This service bulletin replaces FSB 284-047 dated 9.2013.

Date 10.13 Group **284** No. **047** Release **02** Page 1(10)

Oil Level Sensor Harness Wire Splice
 VAH, VHD, VN, VT

FSB 284-047, Oil Level Sensor Harness Wire Splice

New Style Solid Pin Connector

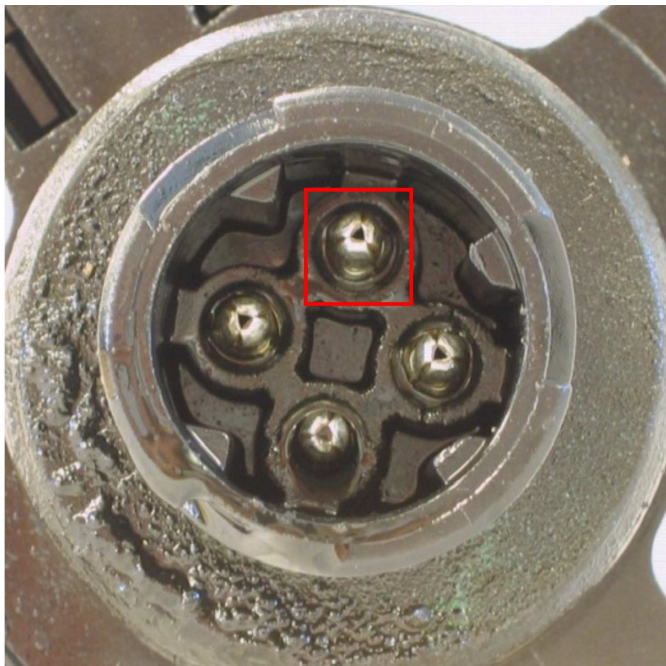
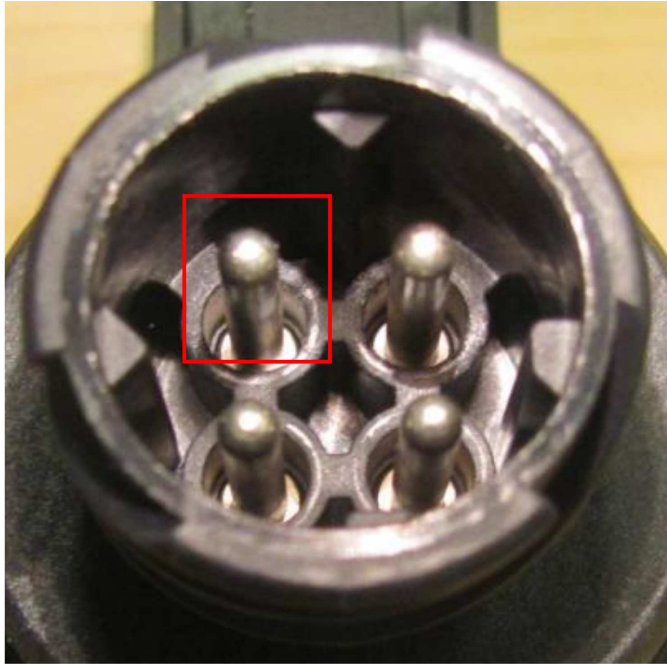
Some VOLVO vehicles built between January 2004 and September 19, 2013 may experience an oil level sensor failure that leads to oil contamination into the engine wire harness. A new anti-wicking pigtail splice kit, part number 85137983, is now available. Follow the procedure below if wicking is observed. Chassis with build date September 20, 2013 and later have the new solid pin connector and no action is required. The oil level sensor part number 21521353 with hollow pin type connector is now replaced with the new solid pin type connector oil level sensor part number 22022794. The new solid pin connector does not allow oil to wick into the engine harness.

Note: The only purpose for the pigtail harness installation is to prevent oil in the harness from migrating back to the new sensor in the event oil has previously wicked into the harness giving the false indication the sensor has failed.

If a sensor is being replaced for electrical faults and oil has not wicked into the harness, **REPLACE THE SENSOR ONLY.**

If a sensor has failed **AND** is wicking oil into the engine harness, **REPLACE THE SENSOR AND INSTALL THE PIGTAIL AS INSTRUCTED IN THIS BULLETIN.**

If the engine harness is being replaced for other reasons and the sensor connector is the older hollow pin type, **REPLACE THE SENSOR ONLY.** The new harness will **NOT** require the pigtail kit.
